## Change of marking for HVCC series

# Product Change Notification

Product Group: Vishay Ceramic Capacitors / May 6, 2020 / PCN-CC-00006-2020 Rev 0

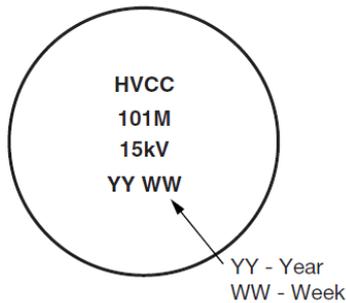
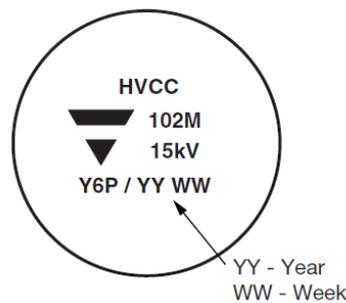
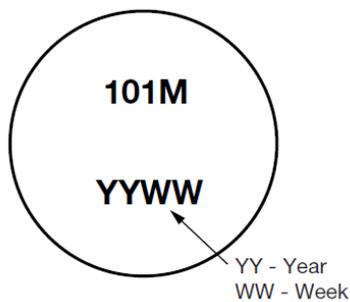
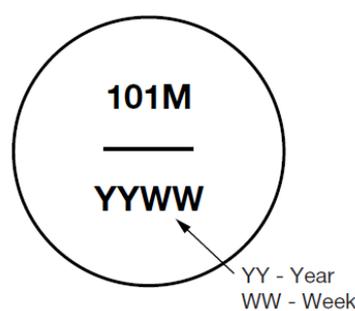
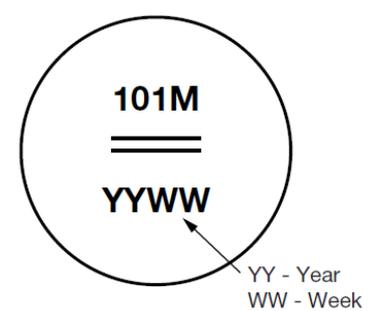
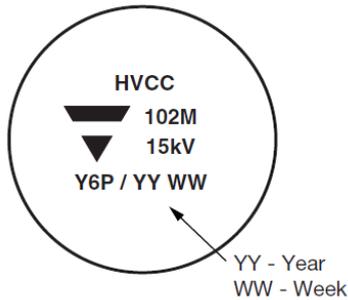
**DESCRIPTION OF CHANGE:** For better readability of marking on the components of the HVCC series we will change the marking for components with diameter less than 12 mm. The part numbers affected can be found in the attached part number list. Please note that there is no change in quality of the components, this change solely includes the marking for better readability. During the implementation mixed shipments are possible.

The marking will change as following: The "HVCC" for the smaller components will disappear and the voltage rating will be changed to lines indicating the rated voltage. Hereby, no line indicates components with 10 kV rated voltage, one line indicates components with 15 kV rated voltage and two lines indicate components with 20 kV voltage rating.
